BOSTON EDISON COMPANY  
800 BOYLSTON STREET  
BOSTON, MASSACHUSETTS 02199

BECO 85-134

License DPR-35  
Docket 50-293

RESPONSE TO NRC ACTION ITEMS

F.W.P. No. F-251

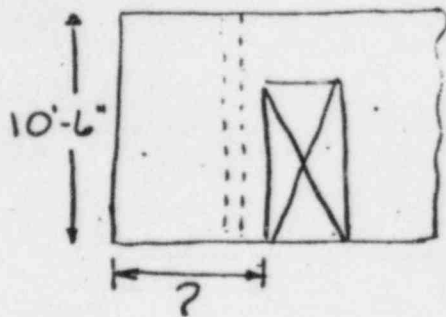
SK-452, WALL 188.105 indicates an overall dimension of 40'-9" & the dim. in question as 9'-3". Please clarify these dimensions.
